Re: Petition No. 1604 – Endurant Energy petition for a declaratory ruling, pursuant to Connecticut General Statutes §4-176 and §16-50k, for the proposed construction, maintenance and operation of an 18.0-megawatt AC battery energy storage facility located at 50 Ucar Street (Parcel No. 70H-55-97), Suffield, Connecticut, and associated electrical interconnection.

Enclosed for filing with the Connecticut Siting Council (“Council”) are Endurant Energy’s responses to the Council’s February 26, 2024 interrogatories.

Figure 4  
Parcel and Site Boundaries

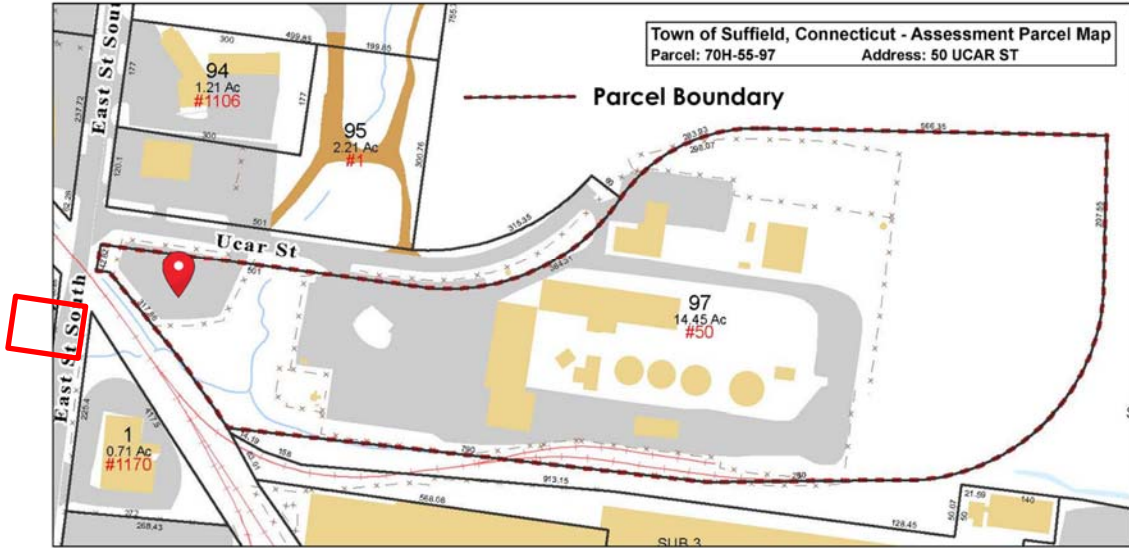
- Q-CSC 3: Submit a map clearly depicting the boundaries of the battery energy storage facility (BESF) site and the boundaries of the host parcel(s). Under Regulations of Connecticut State Agencies (RCSA) §16-50j-2a(29), "Site" means a contiguous parcel of property with specified boundaries, including, but not limited to, the leased area, right-of-way, access and easements on which a facility and associated equipment is located, shall be located or is proposed to be located.
- A-CSC 3: The Site is defined as the area of the host parcel that is to be leased by Endurant and is identified by the BESF perimeter fencing. No rights-of-way, access or easements are associated with the proposed Site. The final dimensions may vary slightly from what is shown depending on utility requirements.

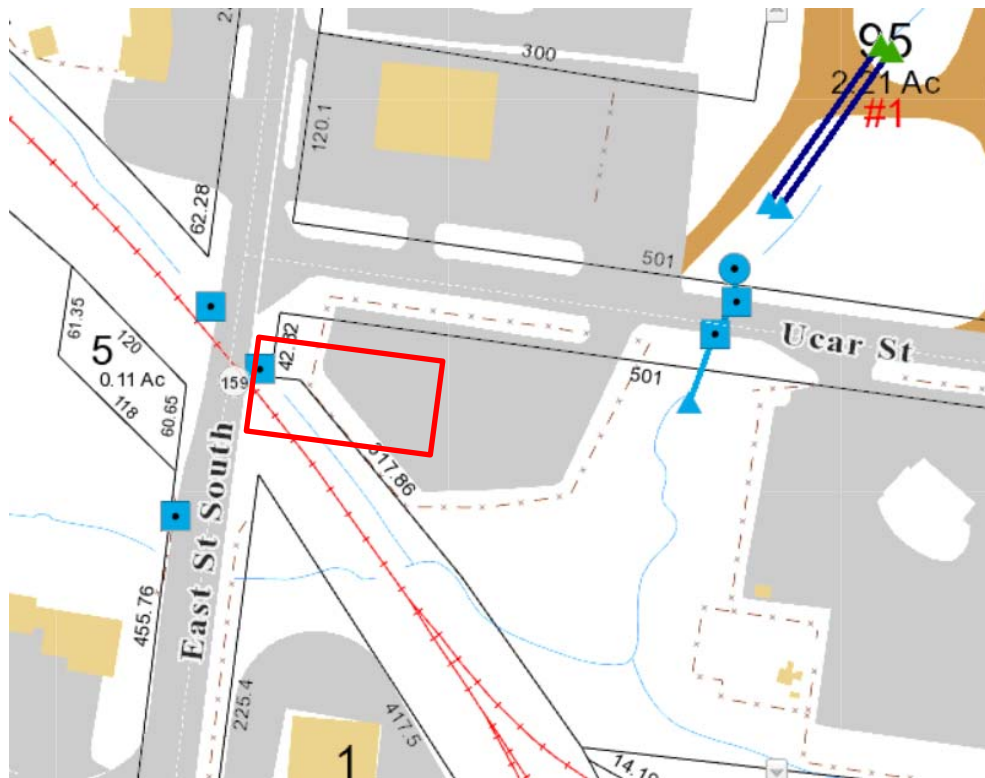
Q-CSC 34: Have drainage characteristics of the proposed site been evaluated to ensure water will not pool around the BESF? Where would stormwater be directed?

A-CSC 34: The site is on an existing levelled paved parking lot. A preliminary survey was undertaken to confirm no critical issues. Stormwater would be directed to existing storm drainage system infrastructure (please refer to image below) anticipated to be to the east of the site. This will be determined during the pre-detailed engineering survey process.
